Tiffin Motorhomes, Inc.
105 2nd Street NW
Red Bay, AI 35582

Tiffin Motorhomes is sending you this letter advising you of a problem with the front TV. It is not secured sufficiently and could fall out when the motorhome is moving. Please follow the work instructions enclosed to make this repair. We are sending you screws "Next Day Air" UPS to use. We are allowing **a half hour** for this job. Do not allow this motorhome to be driven by potential customers until this repair has been made. Please fill out the form attached and send in with warranty claim to be paid. This repair must be made as soon as possible as it has the potential to be very dangerous. **Absolutely under no circumstances are you to allow a customer possession of the motorhome until the repair has been made.**

Allegro Front TV Service Installation

WI-000138

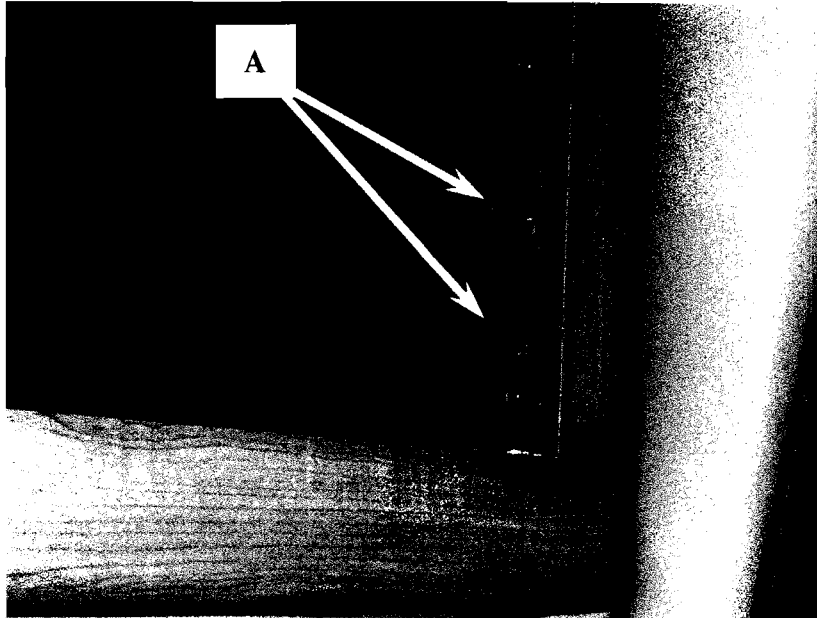
1. Remove Screws "A" From Cabinets on Each Side of the TV enough so that they are not holding the TV Ring "B" in place.

2. Remove the TV Ring "B".

Allegro Front TV Service Installation

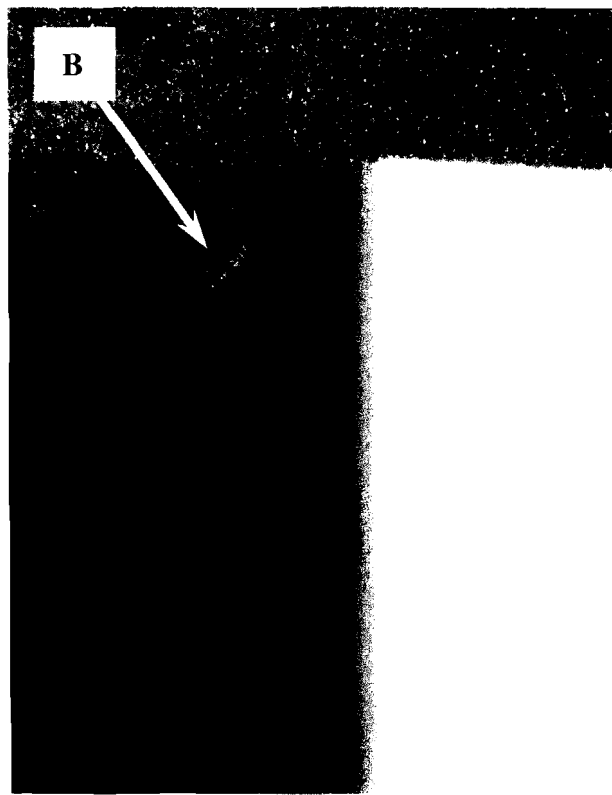
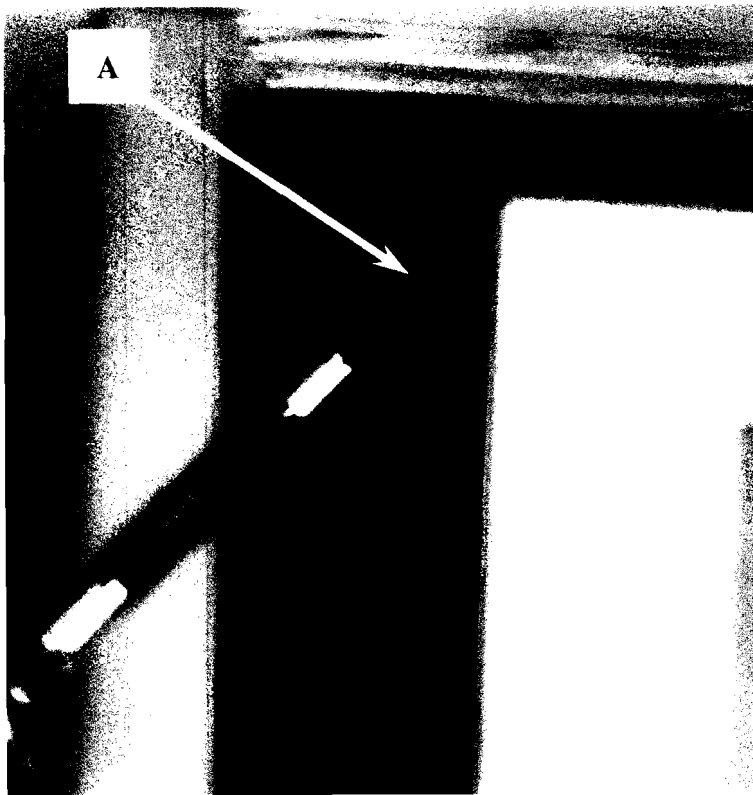
3. Attach TV to Upper Pad Support

- a. Drive Screw "A" thru each top corner of the TV at approximately a 45° Angle through both sides of the TV.
- b. The hole starting location should be approximately ¼" from the top corner of the TV.

Allegro Front TV Service Installation

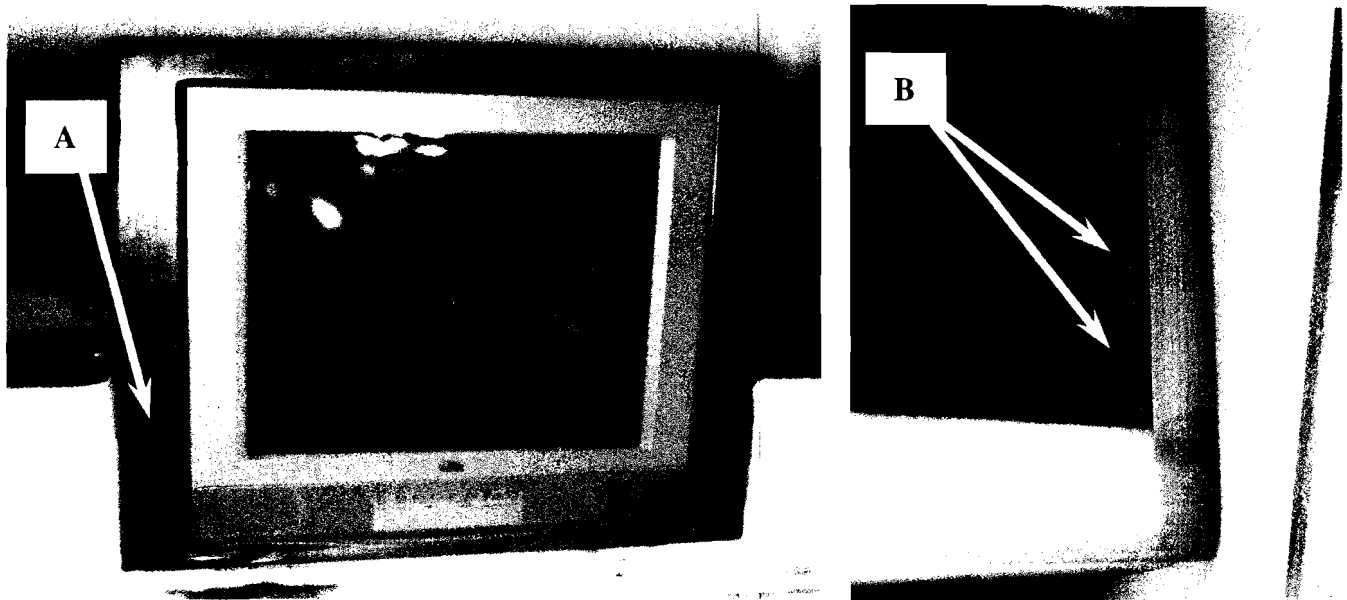
4. Put the TV Ring "A" back in place and Drive the Screws "B" back Down on the Cabinets on Each Side of the TV Compartment.
